**SUBDIVISION &
ZONING AMENDMENT STAFF REPORT****Date: March 17, 2022****APPLICANT NAME**

The Locale Subdivision, Phase Two

Subdivision Approval to create one (1) legal lot of record from an existing metes-and-bounds parcel; and Rezoning from R-1, Single-Family Residential District to B-2, Neighborhood Business District.

DETAIL SITE PLAN

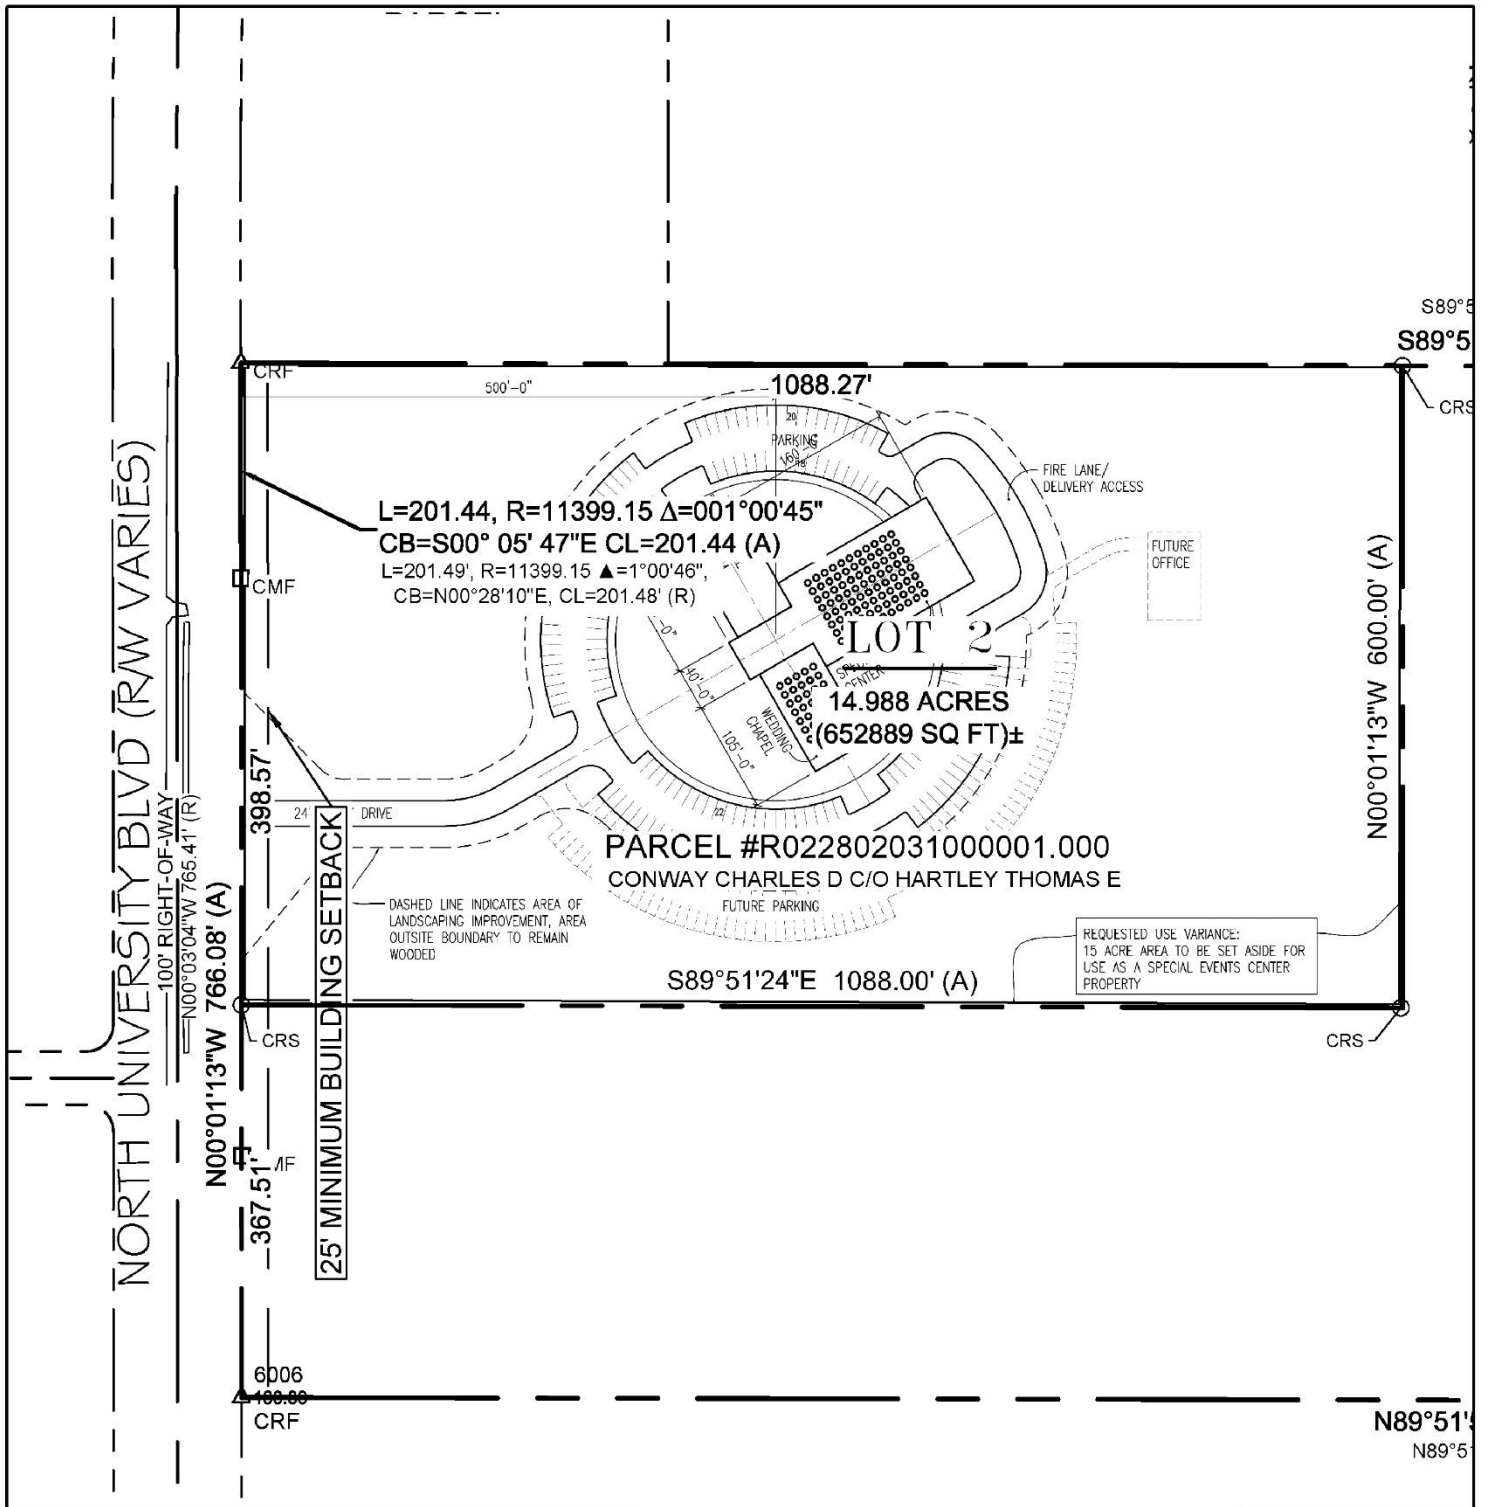
The preliminary plat indicates a 20-foot sanitary sewer easement meandering within the Eastern portion of proposed Lot 1. Therefore, if approved, a note should be required on the Final Plat stating that no structures shall be constructed or placed within any easement without permission of the easement holder. The plat also indicates a 60-foot Gulf South Pipeline Company right-of-way adjacent to the East side of the site. If approved, a note should be required on the Final Plat stating that access to this right-of-way is denied.

The site plan does not provide any building size or parking calculations, dumpster provision or refuse collection information, or public sidewalk within the right-of-way. If the Rezoning is approved, such information will be required on a site plan submitted for construction permitting. No landscaping or tree planting calculations are provided. Therefore, it should be noted that the site will be required to fully comply with landscape area requirements, and tree plantings should be coordinated with staff to insure proper spacing for the trees to thrive. As the site plan appears to provide more than 25 parking spaces, it should be noted that a compliant photometric site plan will be required at the time of permitting. The site plan shows a separate "future office" to be located on the site. The applicant should be made aware that at such time as the "future office" is to be constructed, an Administrative Planned Unit Development will be required.

- 4) retention of the 25-foot minimum building setback line along North University Boulevard;
- 5) placement of a note on the Final Plat stating that no structures shall be constructed or placed within any easement without permission of the easement holder;

- 6) placement of a note on the Final Plat stating that access to the Gulf South Pipeline Company right-of-way adjacent to the East side of the site is denied;
